SNUPPS
EQUIPMENT LOCATION
RADWASTE BUILDING
SECTIONS C & E

UTILITY DRAWING NO.	REV.
10466	M-06015
6

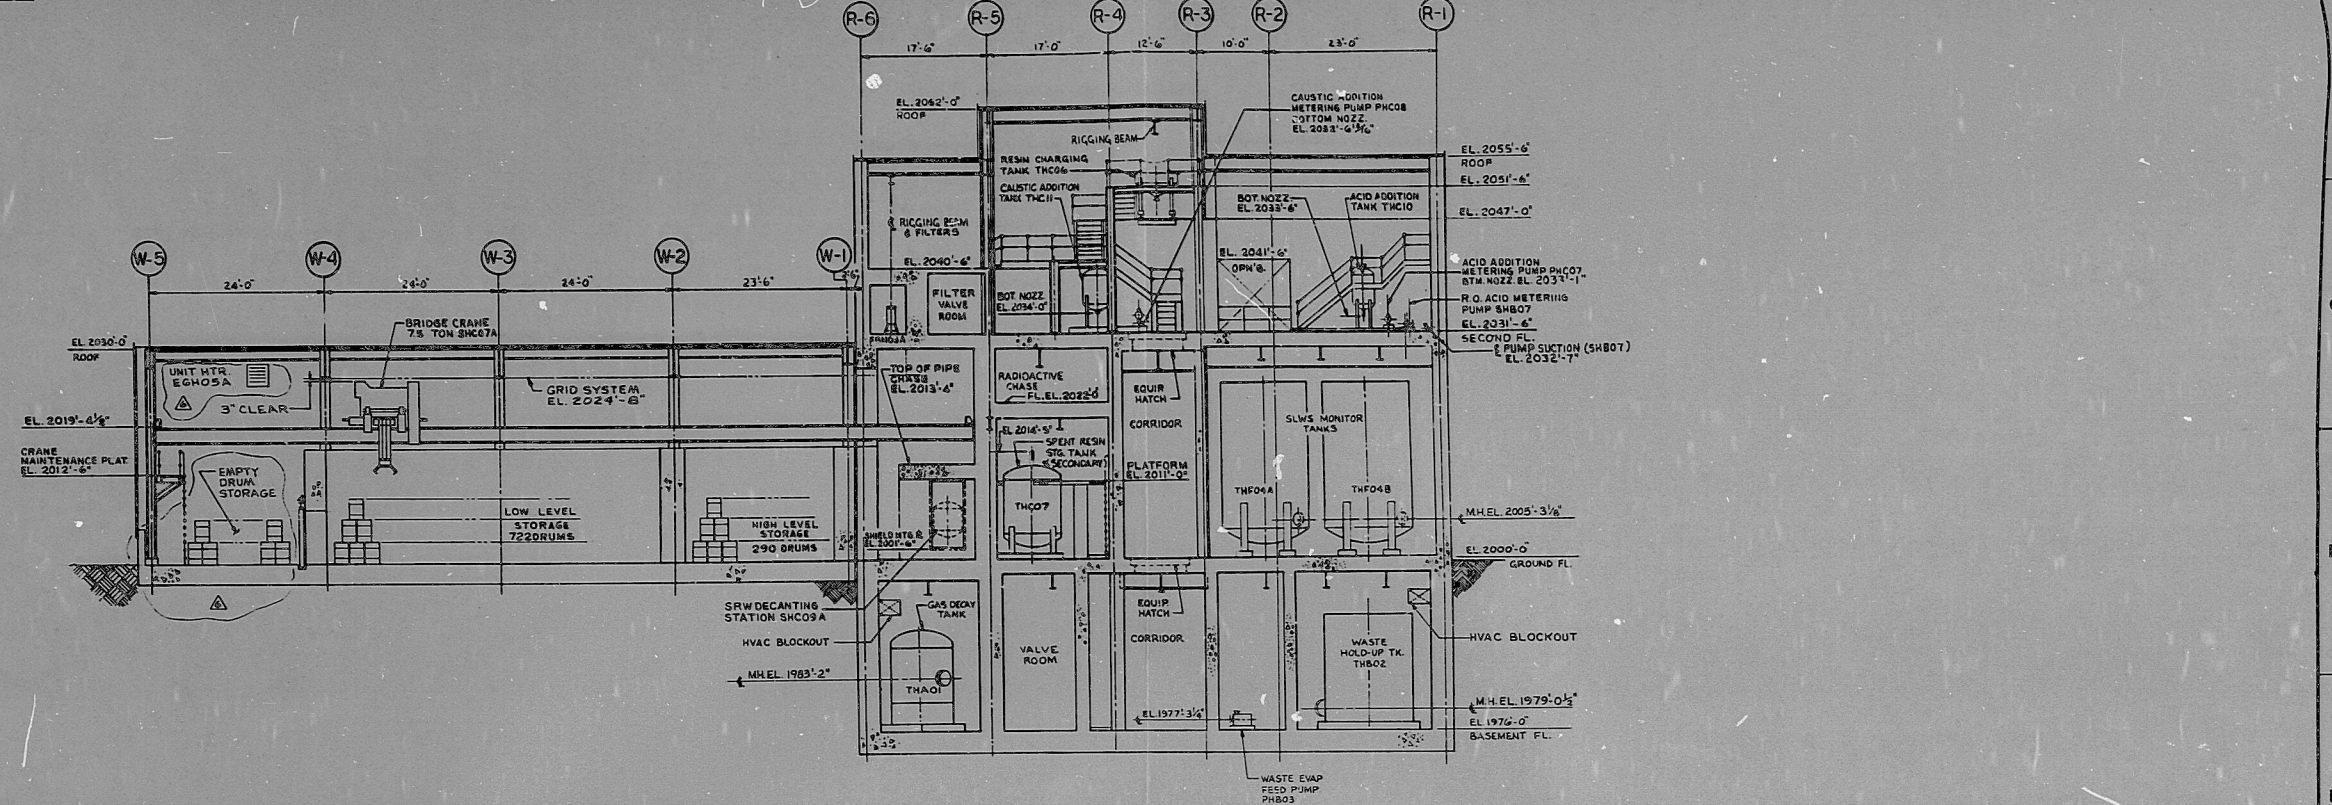
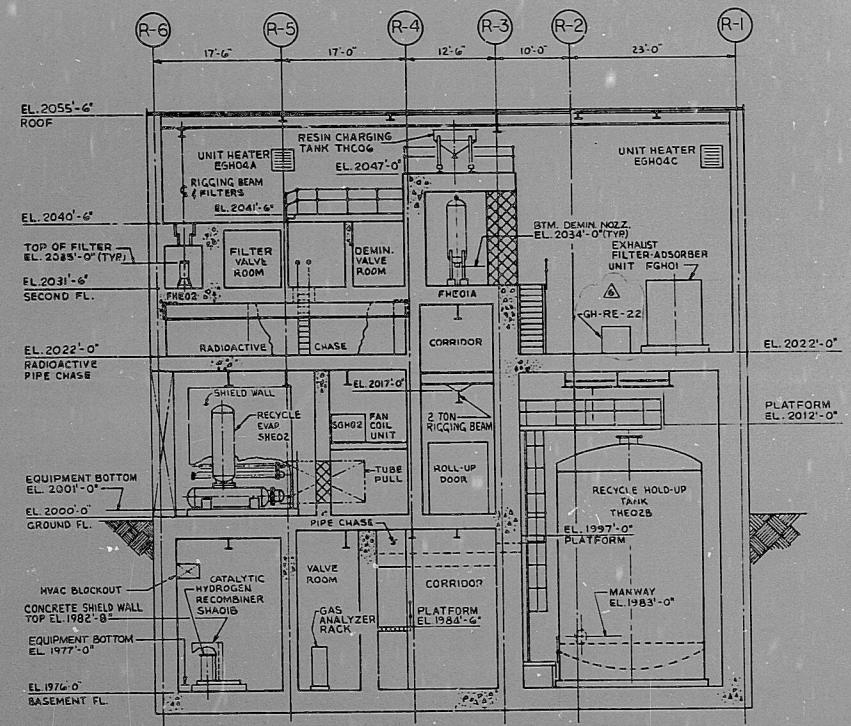
△	ADDED UNIT HTR. ESH04A. PREL. DRUM. STG. AREA. ADDED RADIATION MONITOR QH-RE-22.								
△	ADDED PROF. SEALS, MOD. SHIELD WALL & DELETED HVAC BLOCKOUT.								
△	MOD. LOCATION & ELEVATION OF SHB07. ADDED CONCRETE SHIELD WALLS.								
△	REVISED SECTIONS TO AGREE WITH PLANS. REMOVED HOLD PLATFORM OPENING. EL. 2047'-0" WAS 2045'-0". ACID PUMP PHC07, PHC08 & PHB03 NOZ. ELEVATIONS ADDED. DRUMMING AREA BRIDGE CRANE AND GRID SYS. ELEVATION ADDED. INTERMEDIATE PLATFORM AT EL. 1997'-0" FOR VERT. LADDER (RECYCLE HOLD-UP AREA).								
△	SECTIONS REVISED TO AGREE WITH PLANS. EQUIPMENT ELEVATIONS ADDED.								
△	REVISED EL. 2022'-0" WAS 2021'-0". EL. 2031'-0" WAS EL. 2030'-0". EL. 2040'-0" WAS EL. 2040'-0". EL. 2047'-0" WAS 2045'-0". EL. 2051'-0" WAS 2050'-0". EL. 2055'-0" WAS 2054'-0". EL. 2062'-0" WAS 2060'-0". REVISED COLUMN LINES IN DRUM STORAGE AREA. HVAC BLOCKOUT WAS PIPE BLOCKOUT.
